Concerning Comments on 25GBASE-ER Budget

Kohichi Tamura

20160914

EML TX, APD RX BER

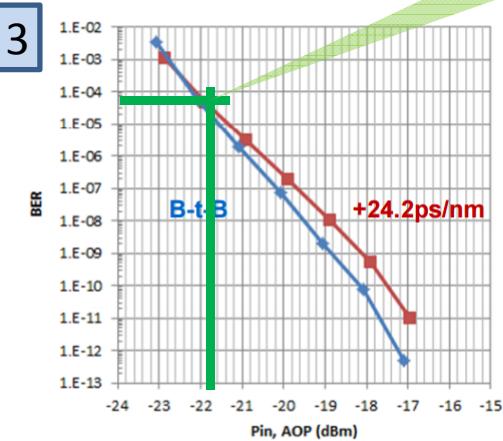
Interpret this as very good Ref Tx into very good 1ch APD Rx?
